**BROWNS FERRY NUCLEAR PLANT (BFN) - UNITS 1, 2, AND 3 -
TECHNICAL SPECIFICATIONS (TS) CHANGES TS-431 AND TS-418 -
EXTENDED POWER UPRATE (EPU) - RESPONSE TO ROUND 6 REQUESTS
FOR ADDITIONAL INFORMATION (TAC NOS. MC3812, MC3743, AND
MC3744)**

**TECHNICAL SPECIFICATIONS (TS) CHANGES TS-431 AND TS-418 -
EXTENDED POWER UPRATE (EPU) - RESPONSE TO ROUND 6 REQUEST FOR
ADDITIONAL INFORMATION (TAC NOS. MC3812, MC3743, AND MC3744)**

RESPONSES TO REQUESTS FOR ADDITIONAL INFORMATION

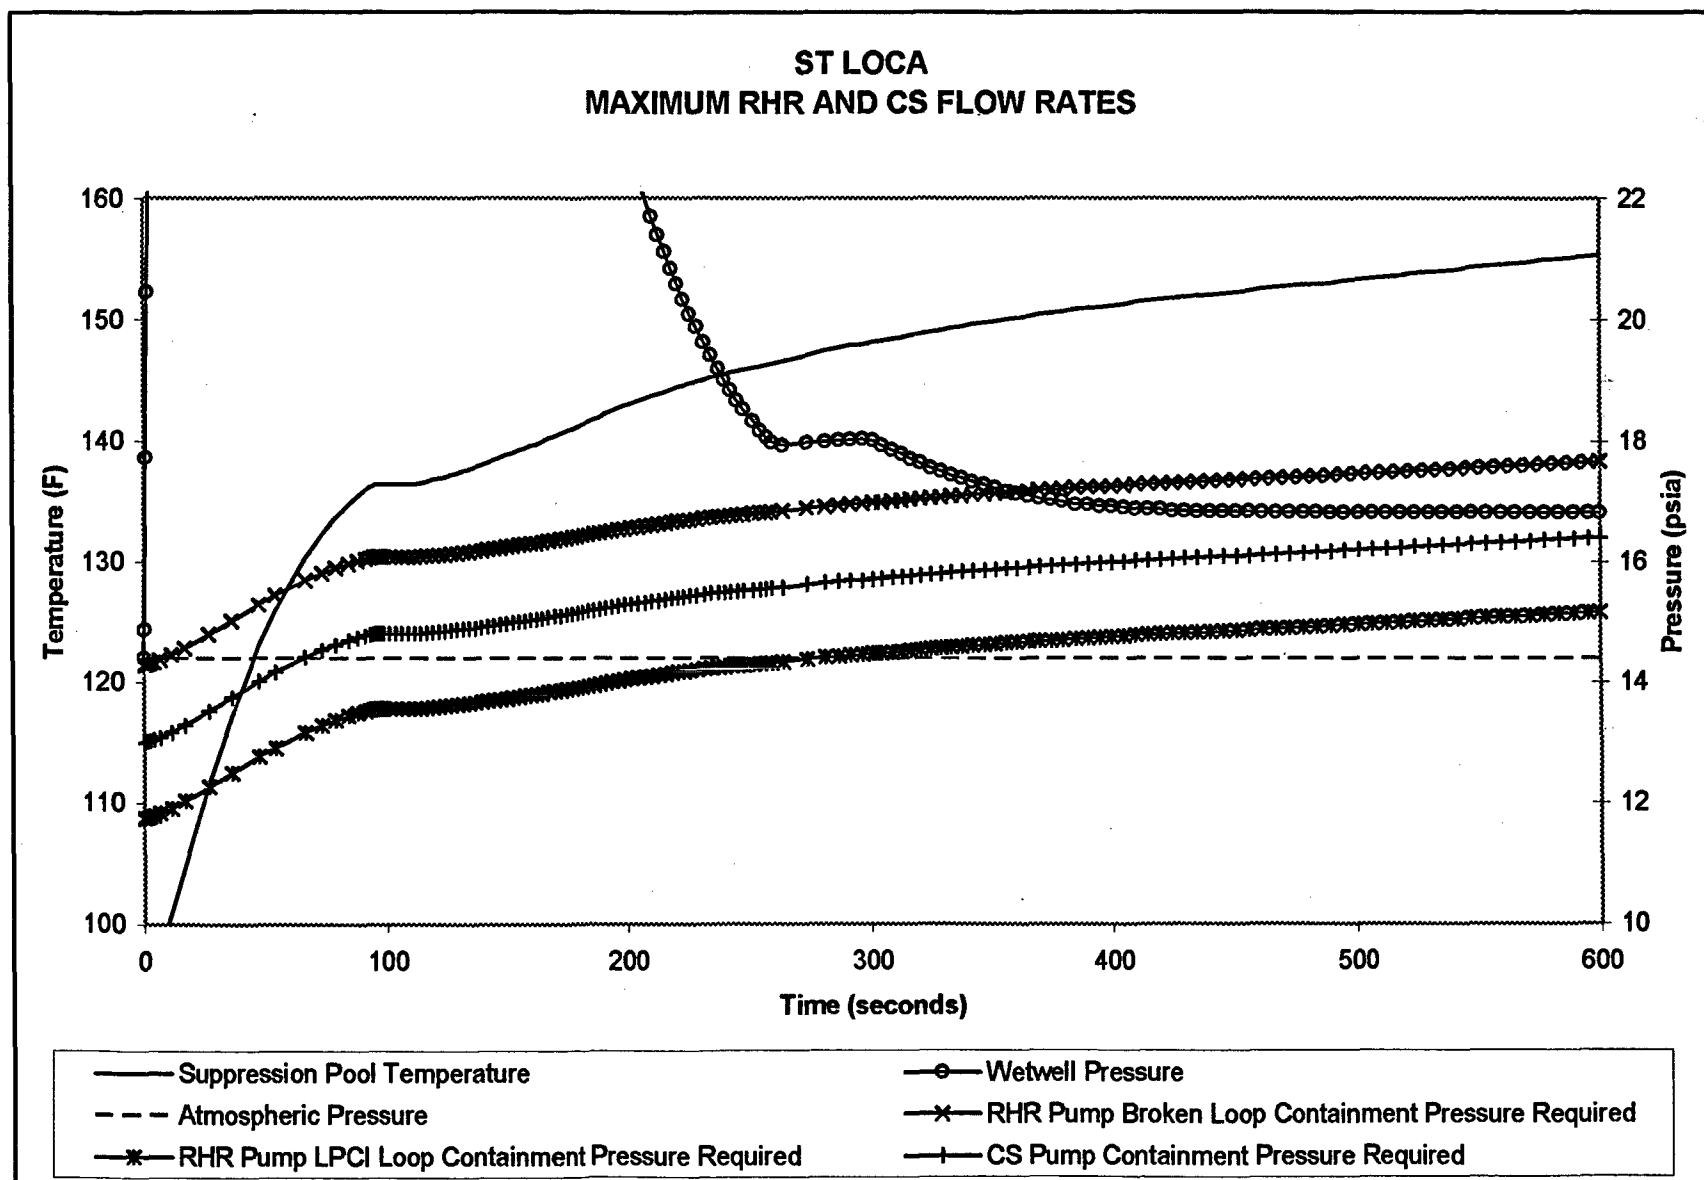
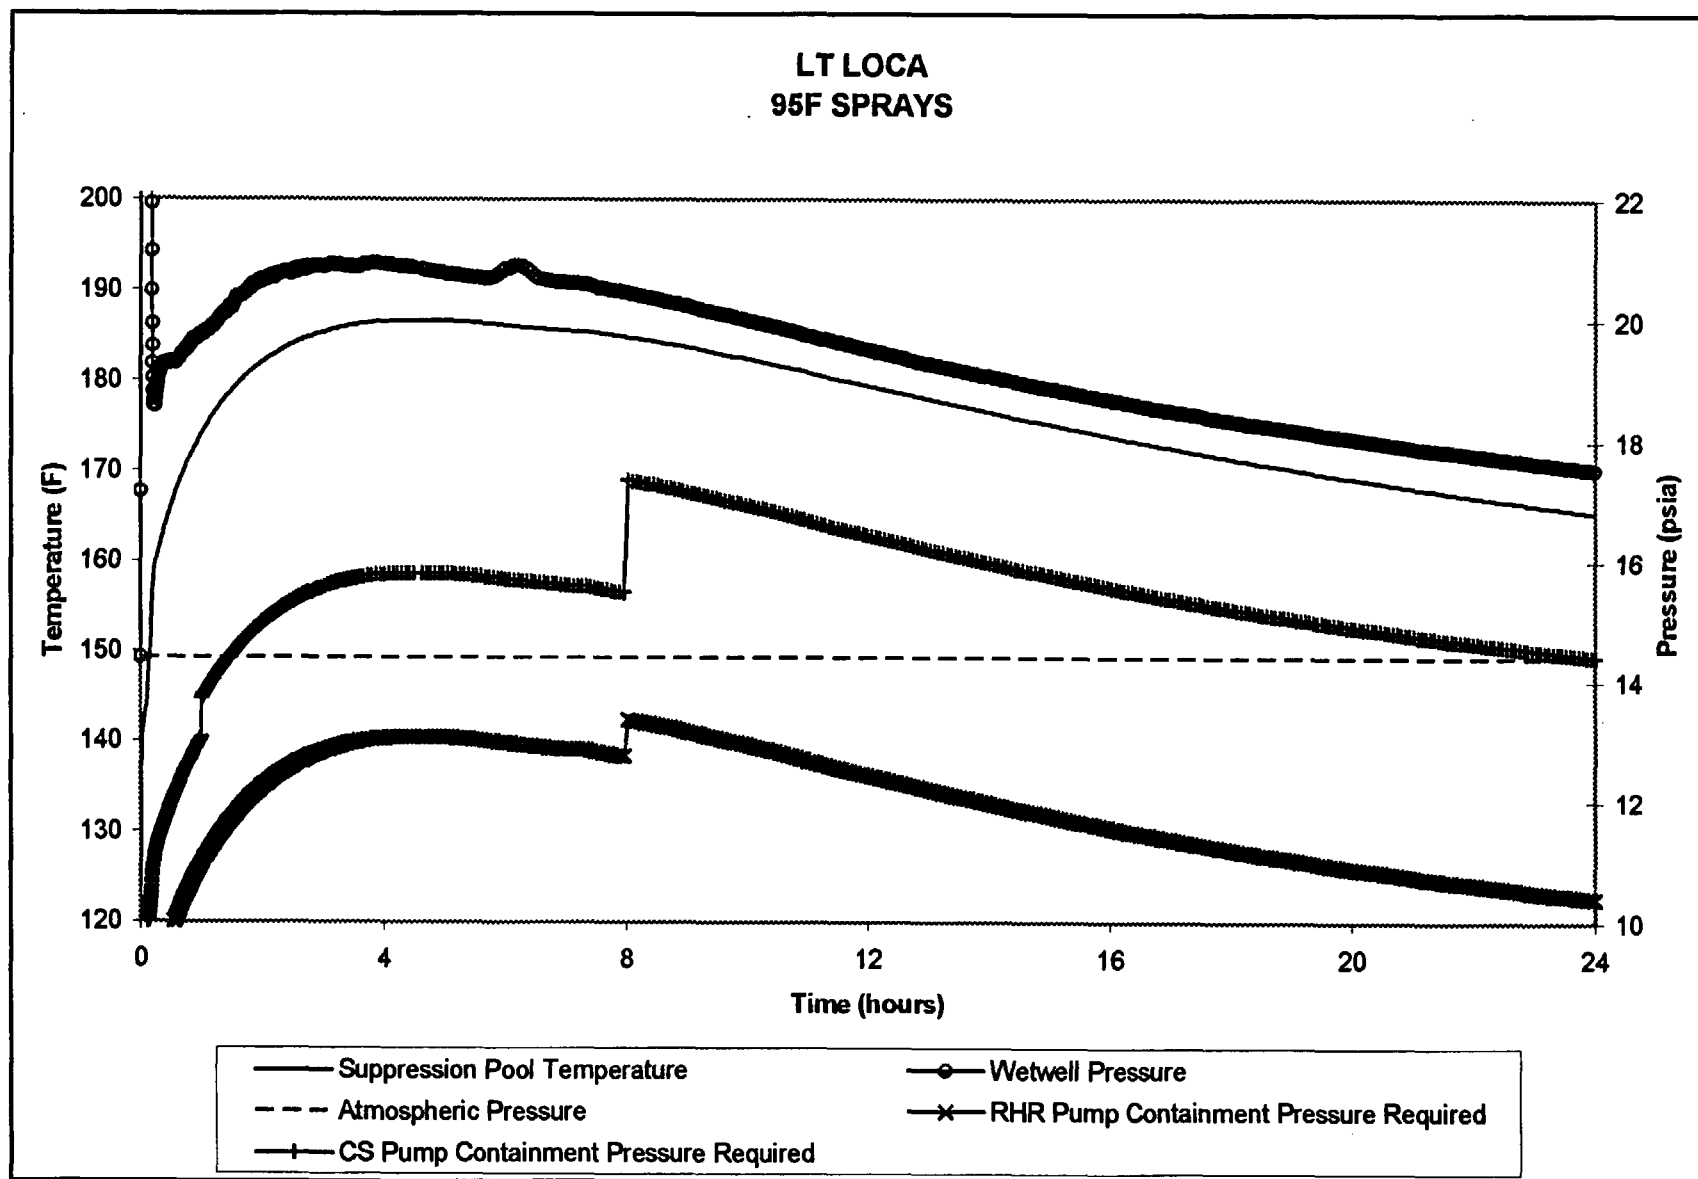
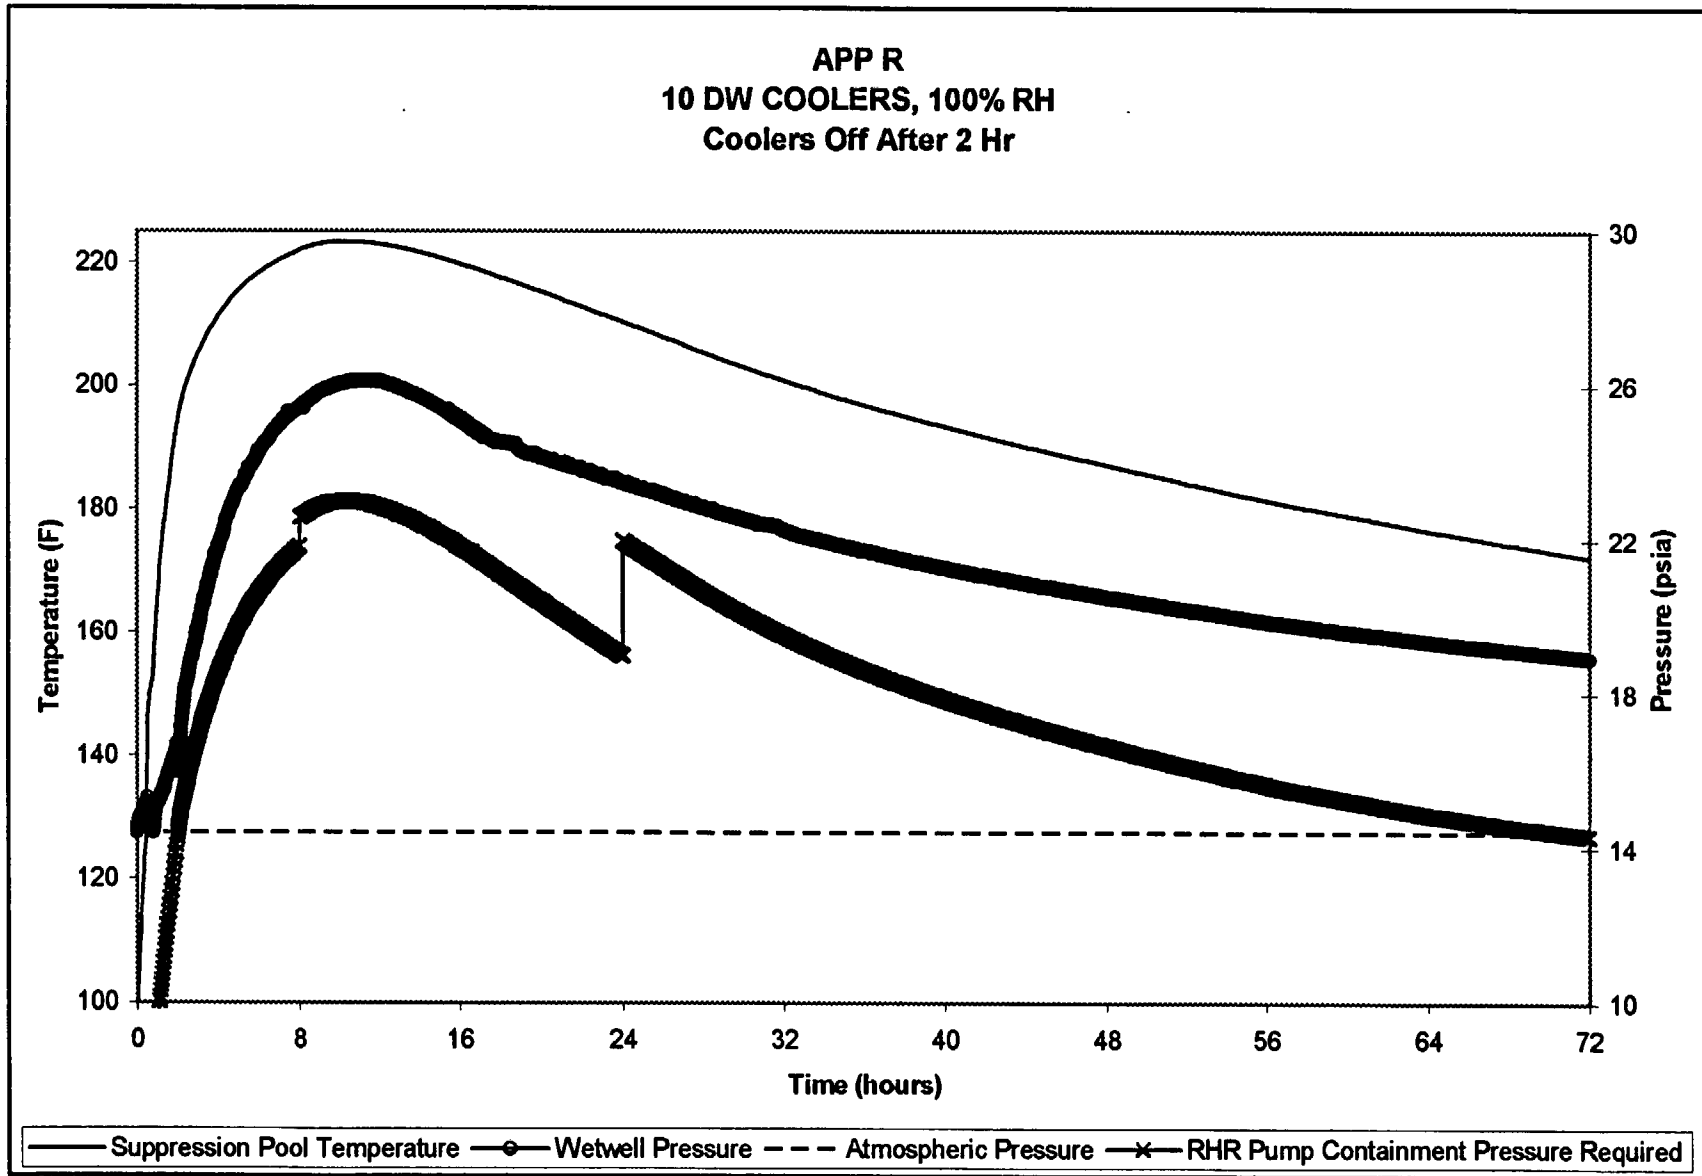
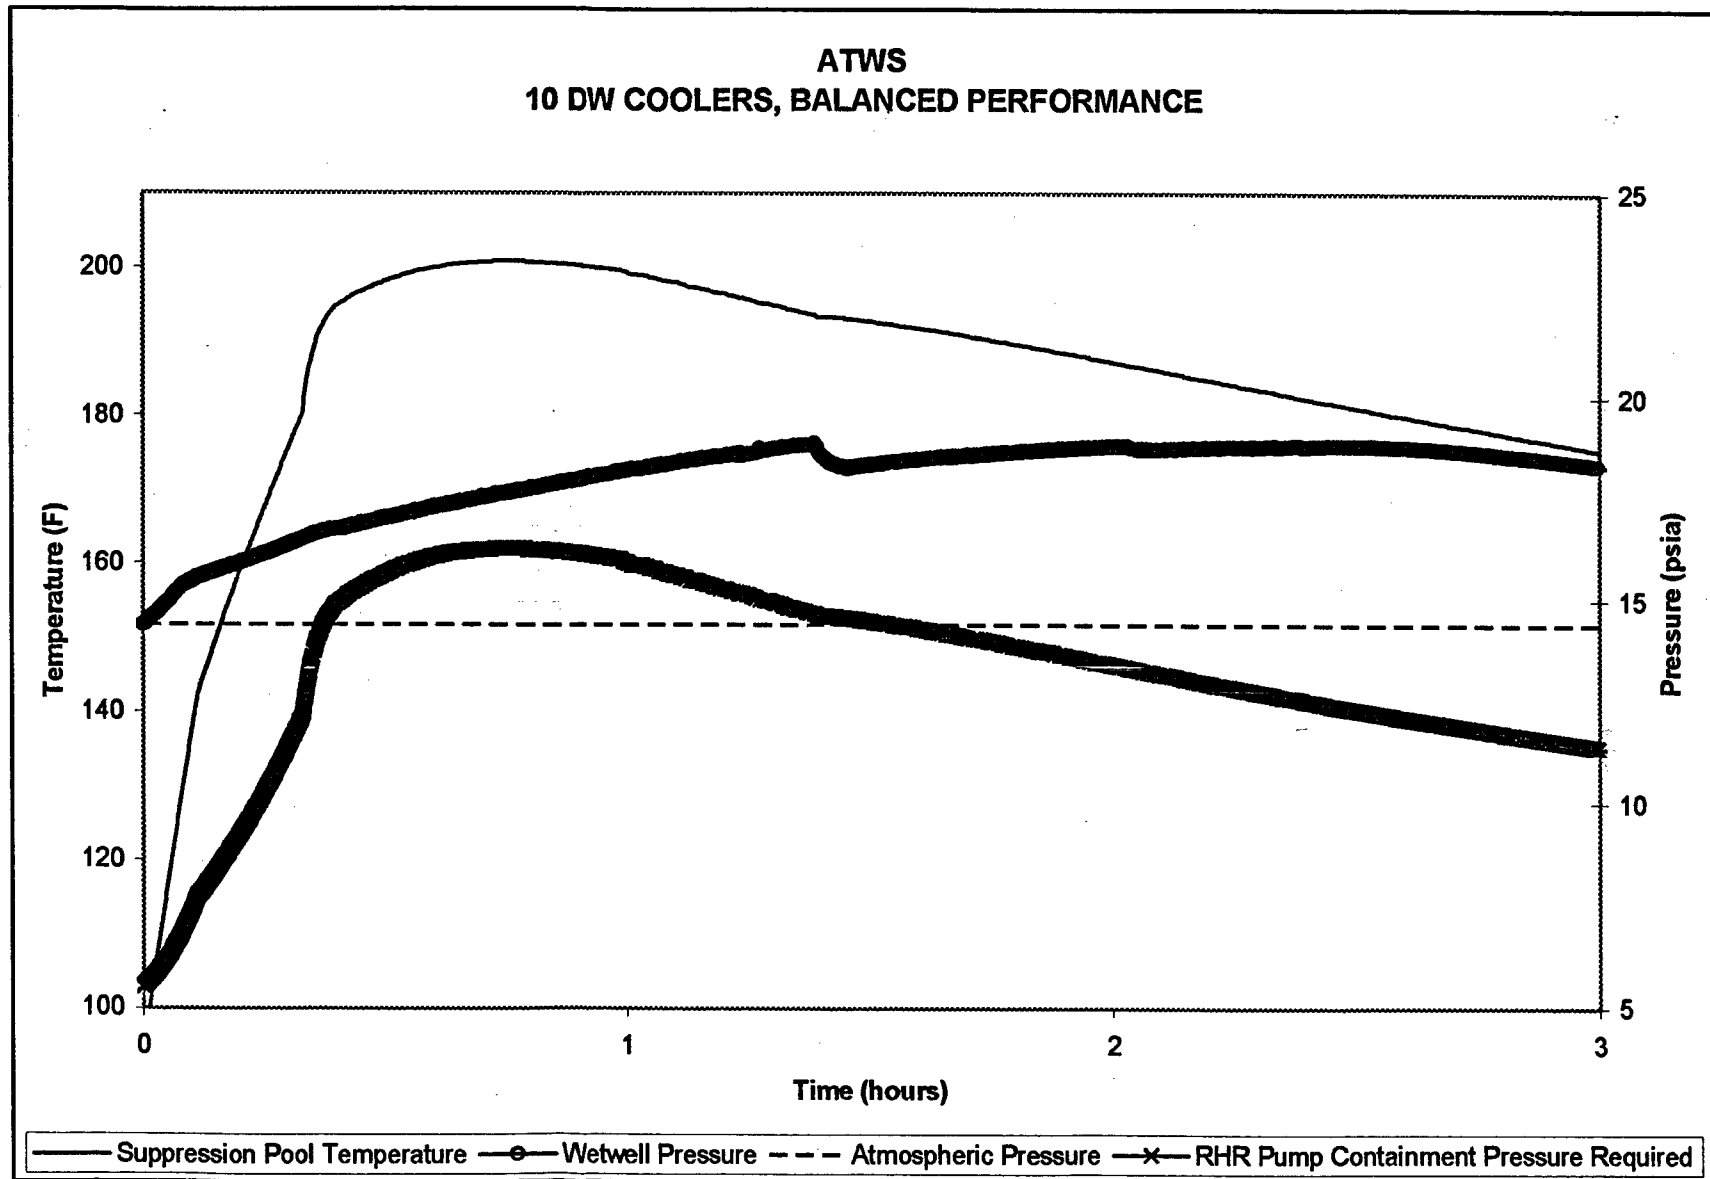
The response to RAI ACVB 18 provided curves of pressures and temperatures for the events crediting containment accident pressure for available NPSH. The curves for ATWS and Appendix R Fire should be extended to provide the total time that containment accident pressure is needed for available NPSH.

To address the discussions provided in TVA responses to ACVB.40/38 and 41/39, NPSH analyses have been re-performed for the LOCA long term, ATWS, Appendix R, and SBO events. Enclosures 3 and 4 are the supporting calculations. Figures ACVB.56/54-1 through 6 show the COP required and COP available for each case as a function of time. These graphs are extended to the time that containment overpressure is no longer needed to provide adequate NPSH.
